TO:	CHAIR AND MEMBERS PLANNING & ENVIRONMENT COMMITTEE
FROM:	JOHN M. FLEMING MANAGING DIRECTOR, PLANNING AND CITY PLANNER
SUBJECT:	APPLICATION BY: HIGHLAND COMMUNITIES LTD. 982 GAINSBOROUGH ROAD PUBLIC PARTICIPATION MEETING ON AUGUST 20, 2013

That, on the recommendation of the Managing Director, Planning and City Planner, the following actions be taken with respect to the application of Highland Communities Ltd. relating to the property located at 982 Gainsborough Road:

The purpose and effect of the requested Zoning By-law amendment is to facilitate the development of two 15 storey apartment towers totalling 176 units (88 each), on the southerly portion of the subject site.

Proposed Site Plan

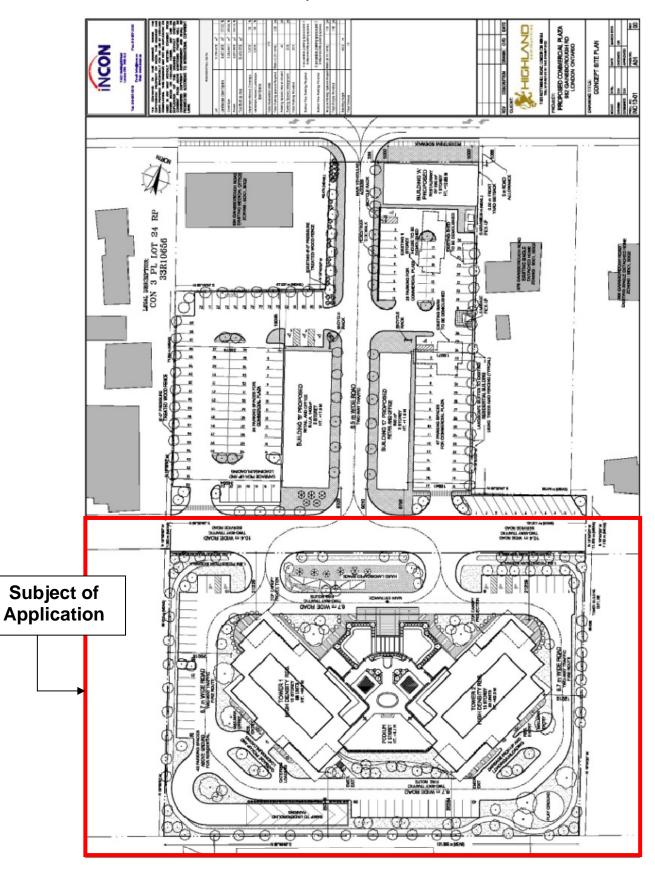
- Remove the drive aisle in front of the building and locate the buildings closer the "service road" in order to avoid a parallel lane situation. This will also create a larger distance separation between the proposed towers and the existing tower to the south.

- Include a two storey residential podium base for the entire building length along the "service road" frontage in order to continue the scale of development of the proposed commercial development directly to the north. Ensure that active building spaces (such as; residential units, lobbies, and amenity areas) with windows and doors are located along the internal road frontages in order to create an active building edge along the street.

- Ensure the main lobby entrance into the apartment buildings acts as the view terminus
 of the proposed internal road (running north-south). Alternatively, an element of public
 art could be placed strategically within the proposed "hard landscape space" to act as
 the view terminus.

- Extend the proposed "hard landscape space" from the edge of the building face into the intersection of the service road and internal drive in order to create a forecourt space(shared space) linking the main lobby with the proposed commercial main street to the north.

- Examine opportunities to eliminate as much surface parking as possible, in particular there should be no parking located in front of the apartment buildings. Any parking visible from the "service road" should be screened using enhanced landscaping in order to create a positive pedestrian experience.

- Examine opportunities to narrow the width of the "service road" as well as include onstreet parking (parallel or angled) in order to create a more functional road cross section.

- (b) The Site Plan Approval Authority, **BE REQUESTED** to address the following items through the site plan approval process:
 - Ensure pedestrian paths are situated to maximize their direct and continuous connection with pedestrian paths in the commercially zoned portion of the site to the north;

- ii) Detail the design of the 'hard landscape space' north of the podium component to create a 'forecourt' shared space linking the lobby entrance with the service road through the use of continuous paving treatments and landscaped features positioned to delineate vehicular and pedestrian pathways; .

- iii) Position the lobby entrance, a public art installation, or significant landscape element to create a view terminus, visible from Gainsborough Road, aligned with the internal road connecting the residential portion of the site with Gainsborough

- iv) Minimize surface parking and ensure all parking visible from the 'service road' is screened to emphasize the pedestrian quality in the north part of the residentially zoned portion of the site; and
